UNITED STATES PATENT AND TRADEMARK OFFICE

APPLICATION NO.	FILING DATE	FIRST NAMED INVENTOR	ATTORNEY DOCKET NO.	CONFIRMATION NO.
10/710,788	08/03/2004	Alexander Stoll	81101893/FMC 1770 PUS	4787
28395	7590	12/01/2005	EXAMINER	
BROOKS KUSHMAN P.C./FGTL 1000 TOWN CENTER 22ND FLOOR SOUTHFIELD, MI 48075-1238			ROSS, DANA	
			ART UNIT	PAPER NUMBER
			3722

Office Action Summary

DETAILED ACTION

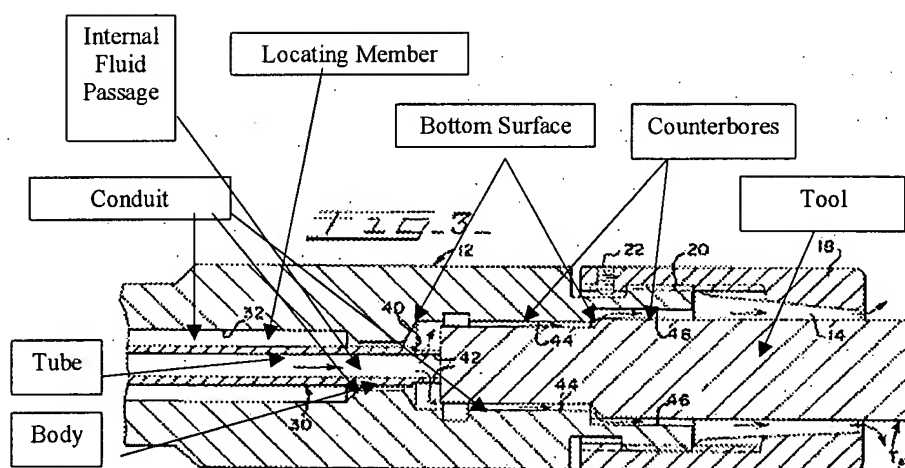
5. Claims 1, 4, 5, 7, 8, 9, 11-15, 18 and 19, as best understood, are rejected under 35 U.S.C. 102(b) as being anticipated by US Pat. No. 4,640,652 (Rivera, Jr., hereafter '652).

'652 teaches a tool holder for coolant deliver with a plurality of bores and a bottom surface, a conduit with first and second diameters and internal fluid passage (see figure 3 below) and spring 34 (see figure 2); the connection tube with a section with a smaller outside diameter than another section of the tube (see figure 3 below) with the inside of the tube engaging with the internal fluid passage. It is noted that '652 teaches a chamfer on a flange portion (see figure 1, for example).
